SUBJECT: ISSUANCE OF AMENDMENT - MILLSTONE NUCLEAR POWER STATION,
UNIT NO. 2 (TAC NO. MA2340)

Amendment No. 226
License No. DPR-65

ATTACHMENT TO LICENSE AMENDMENT NO. 226

SAFETY EVALUATION BY THE OFFICE OF NUCLEAR REACTOR REGULATION

FIGURE 2.1-1
 REACTOR CORE THERMAL MARGIN SAFETY LIMIT-
 FOUR REACTOR COOLANT PUMPS OPERATING

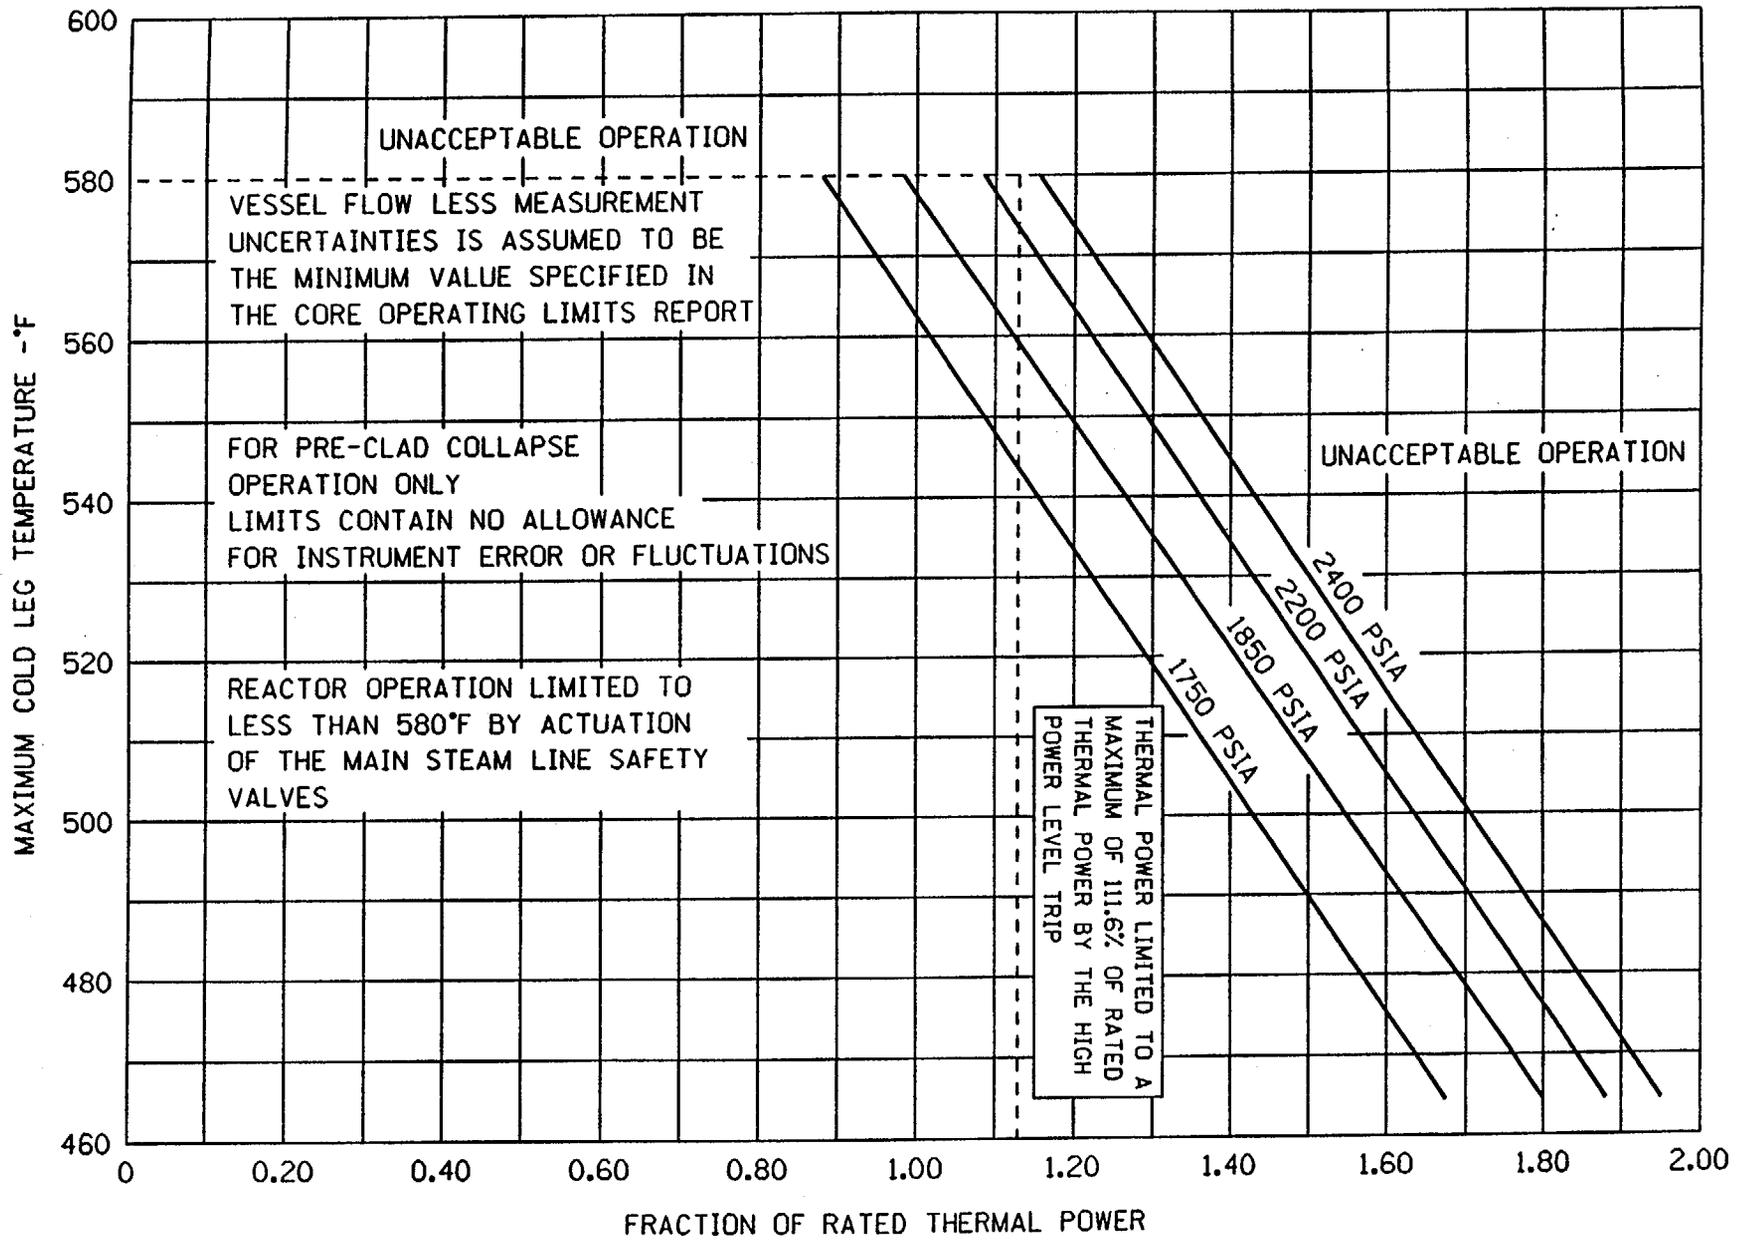
- TS Figure 2.1-1, "Reactor Core Thermal Margin Safety Limit - Four Reactor Coolant Pumps Operating." Revise the value of the maximum thermal power that is limited by the high power level trip, from "112%" to "111.6%."

In its submittal, the licensee stated that this value is currently used in the safety analysis and is consistent with the maximum allowed high power trip SP of 106.6% + 5% uncertainty, which was approved by the staff in License Amendment No. 61, dated October 6, 1980. The staff has reviewed the change and finds it acceptable.
